## Charlotte-Mecklenburg Planning Department

**SUBJECT:** Administrative Approval for Petition No. 2002-109 Mullaney, Grillo, Whitaker, Mc Broom

RETAIL SPACE  
3000 NORTH DAVIDSON STREET  
CHARLOTTE, NC 28205

1 SITE PLAN / LANDSCAPE PLAN  
3/32" = 1'-0"

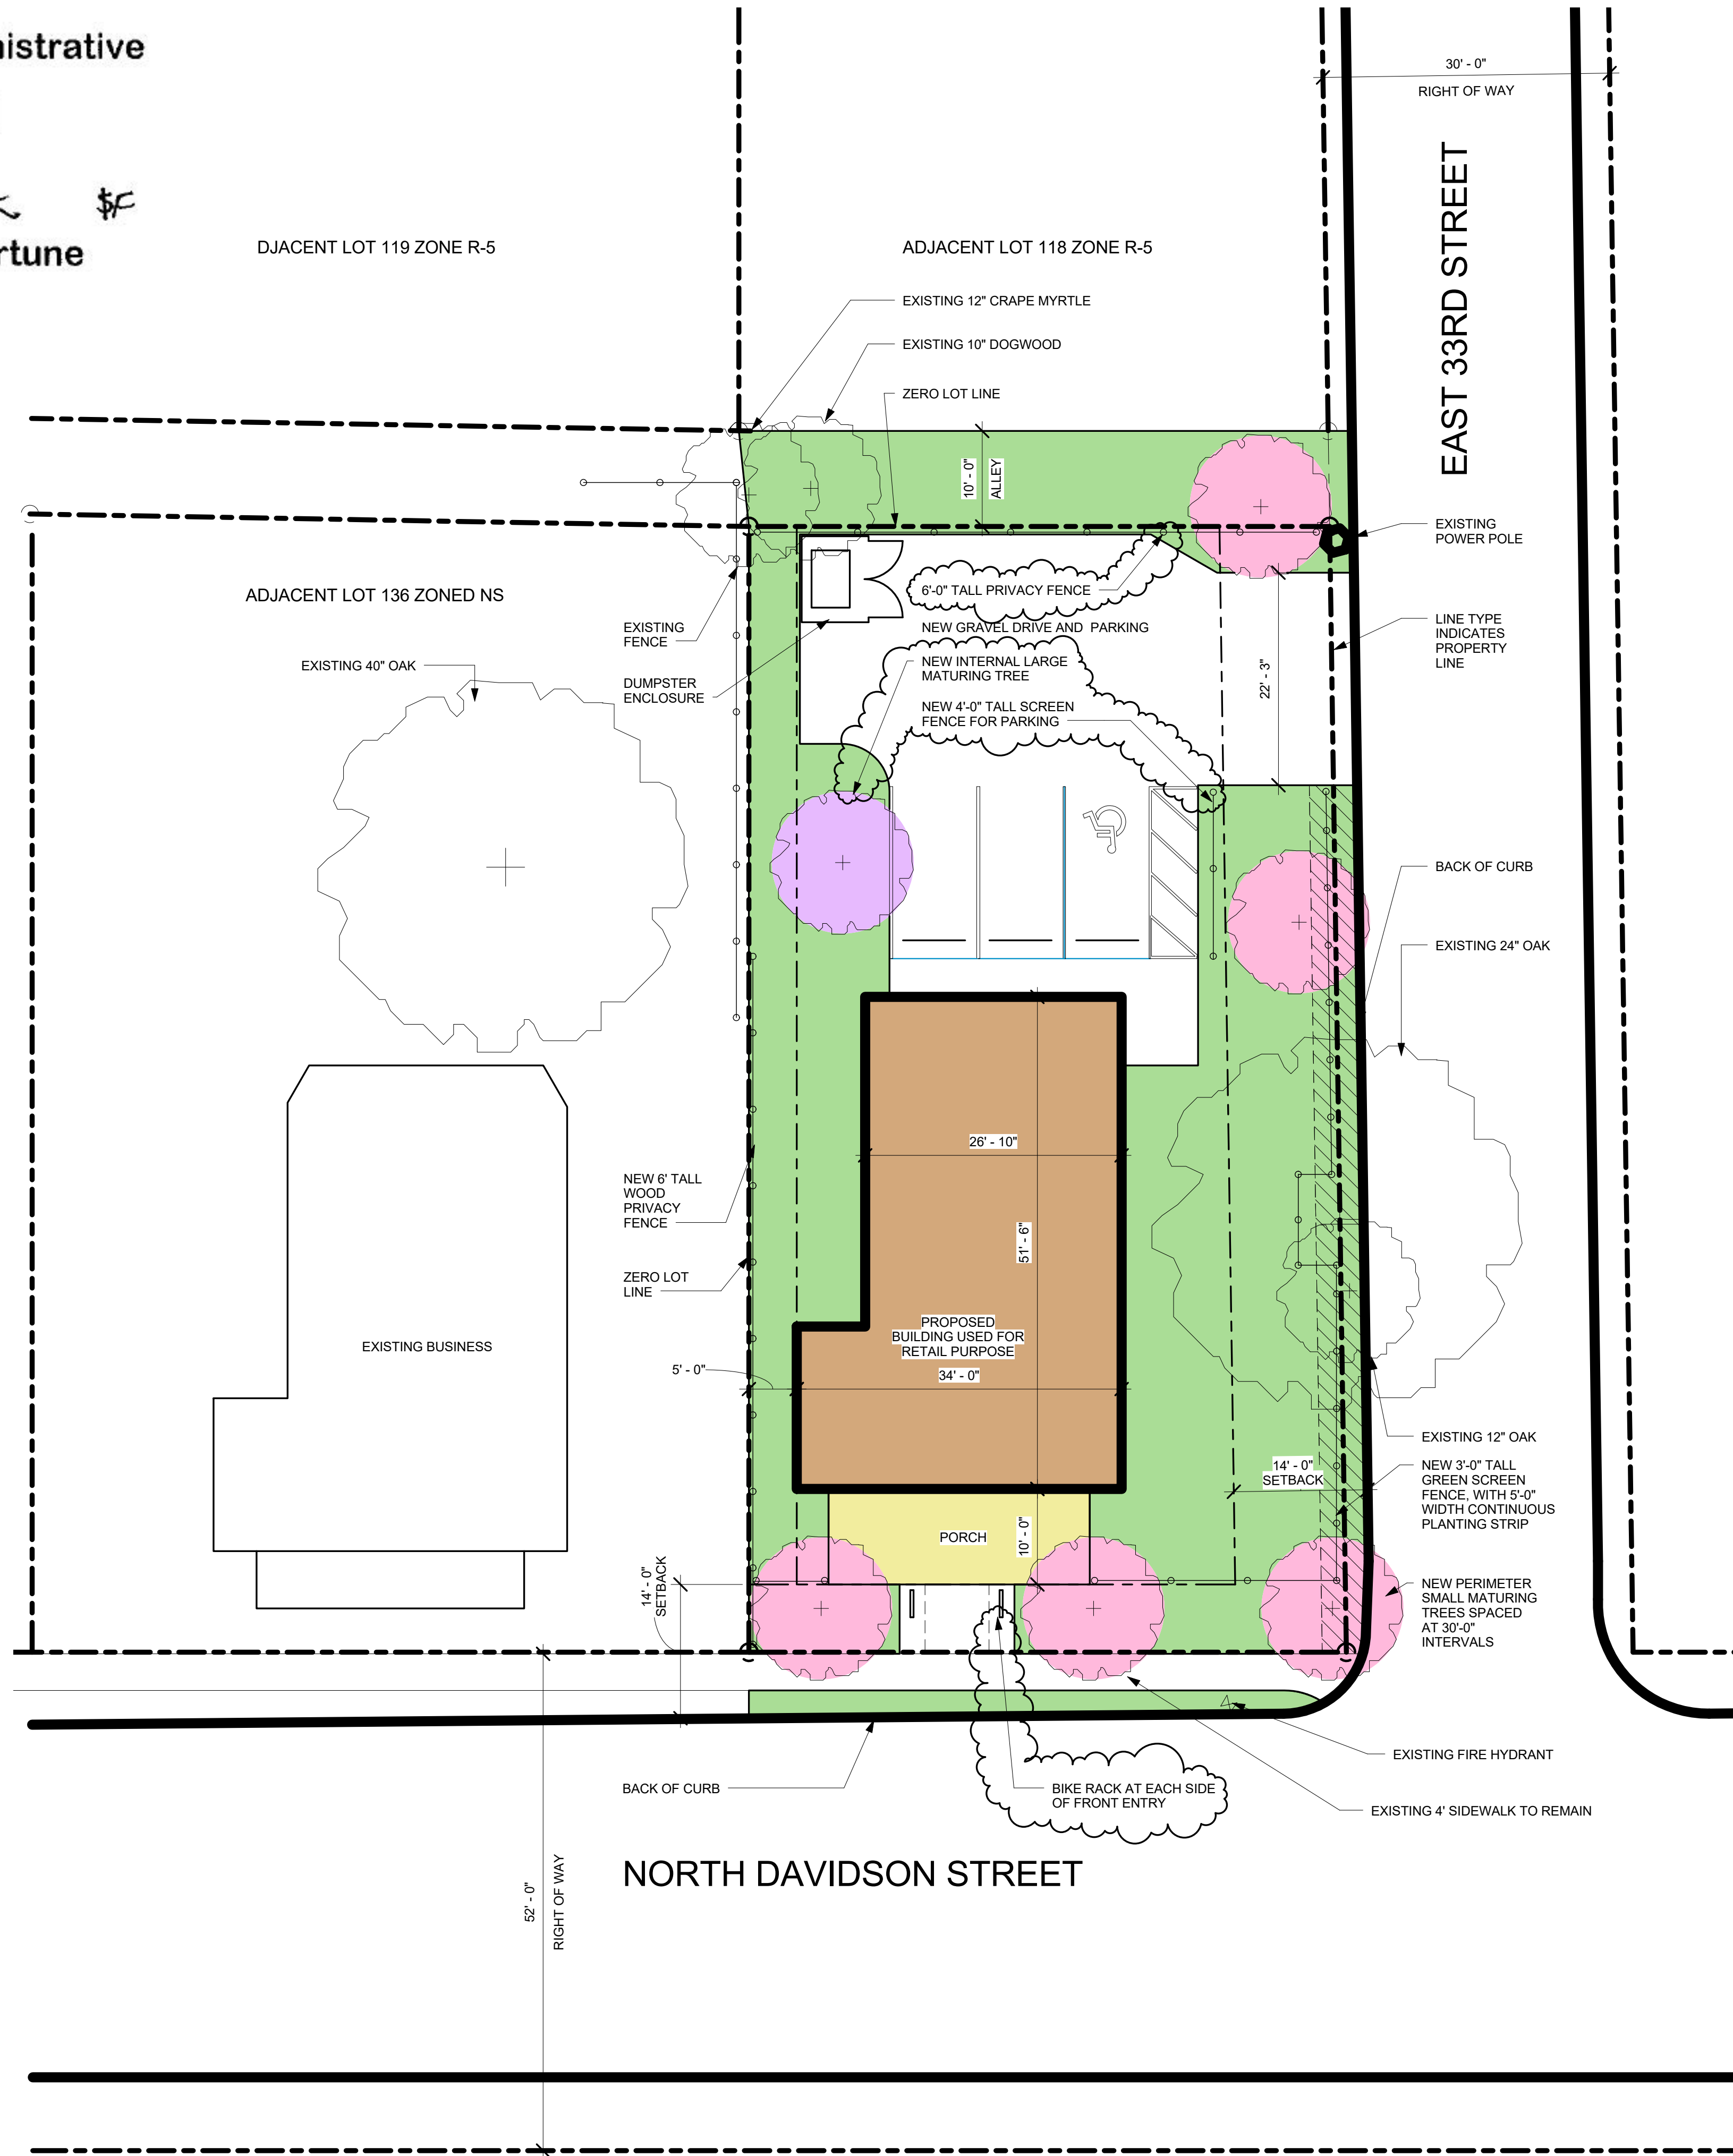
- To allow the development of a new commercial structure for Lot 136.
- Proposed building elevations
- Site layout

- The site plan complies with the conditional notes and still meets the intent of the approved site plan by the City Council.
